Item Name: Crosstube Turning Detail

DART AEROSPACE LTD		Work Order:	94345
Description: Crosstube Assembly (205/212/412 Low Fwd)		Part Number:	D212-664-147
Inspection Dwg: D212-664-147 Rev: B		Page 1 of 2

DRAWING NO. D212-664-147	TITLE CROSSTUBE ASS'Y (205 LOW FWD)	REV. B	DART AEROSPACE LTD ENGINEERING ORDER		D.E.O. NO. D212-664-147-B-1	SHEET NO. SHEET 1 OF 1	SCALE NTS
DRAWN 92	CHECKED ASS	MFG. APPR. 183	APPROVED W.P.		DE APPR. H		
DATE 11.07.15	DATE 11.07.20	DATE 11.07.21	DATE 11/07/21		DATE 11.07.21

REPLACE MAGNOBOND WITH PROSEAL.

**D212-664-147/-147B
ASSEMBLY DETAIL**

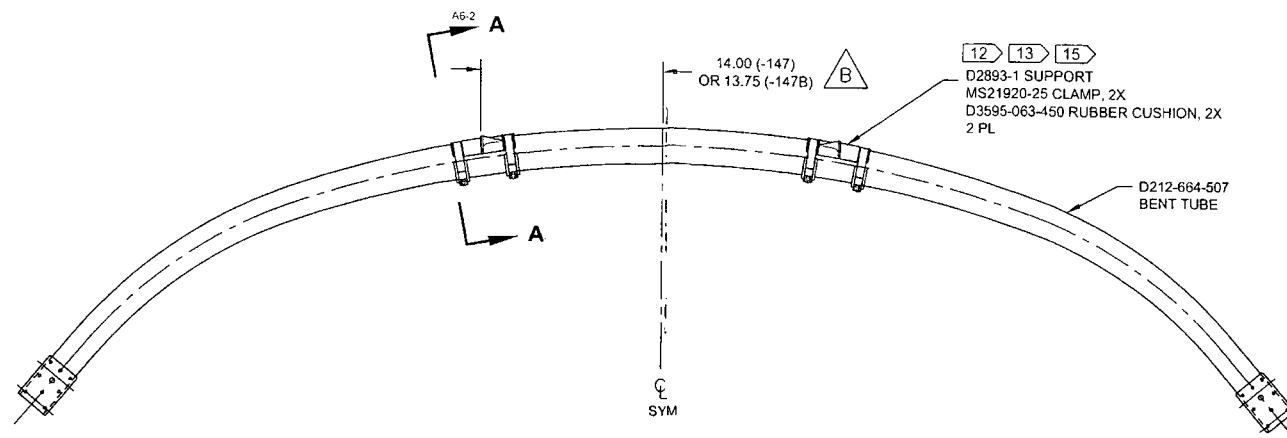
Item	Qty -147	Qty -147B	Part Number	Description
9	A/R	A/R	PROSEAL 890 B-2	SEALANT, AMS-S-8802 CLASS B-2

9	A/R	A/R	MAGNOBOND 6398	ROCKWELL SPECIFICATION RBO-120-023 ADHESIVE (TEXTRON/BELL SPEC. 299-947-100, TYPE II, CLASS 2 ADHESIVE)
---	-----	-----	----------------	---

NOTE 12 & 15, SHEET 1 IS AMENDED AS FOLLOWS:

- 12) TO INSTALL D2893-1 SUPPORT: ABRASE MATING SURFACE OF SUPPORT AND CROSSTUBE WITH 180-GRIT SANDPAPER AND REMOVE RESIDUE WITH MEK (OR EQUIVALENT). APPLY A 0.04" TO 0.07" THICK LAYER OF PROSEAL 890 CLASS B-2 (OR AMS-S-8802 CLASS B-2) SEALANT TO MATING SURFACE OF SUPPORT.
- 15) TORQUE CLAMPS 80 TO 100 IN-LB. ENSURE AT LEAST 1.5 THREADS SHOWING IN SAFETY AND THAT NUT HAS NOT BOTTOMED-OUT AFTER TORQUING. **PRIOR TO PACKAGING, RE-CHECK TORQUE ON CLAMPS AFTER PROSEAL 890 SEALANT HAS CURED FOR 72 HOURS.**

- 12) INSTALL D2893-1 SUPPORT USING 0.03" TO 0.06" THICK LAYER OF MAGNOBOND 6398 TO THE SURFACE OF D2893-1 THAT WILL BE IN CONTACT WITH THE CROSSTUBE PER QSI 015. LET CURE FOR 12 HOURS AFTER INSTALLATION AND PRIOR TO PACKAGING.
- 15) TORQUE CLAMPS 80 TO 100 IN-LB. ENSURE AT LEAST 1.5 THREADS SHOWING IN SAFETY AND THAT NUT HAS NOT BOTTOMED-OUT AFTER TORQUING.
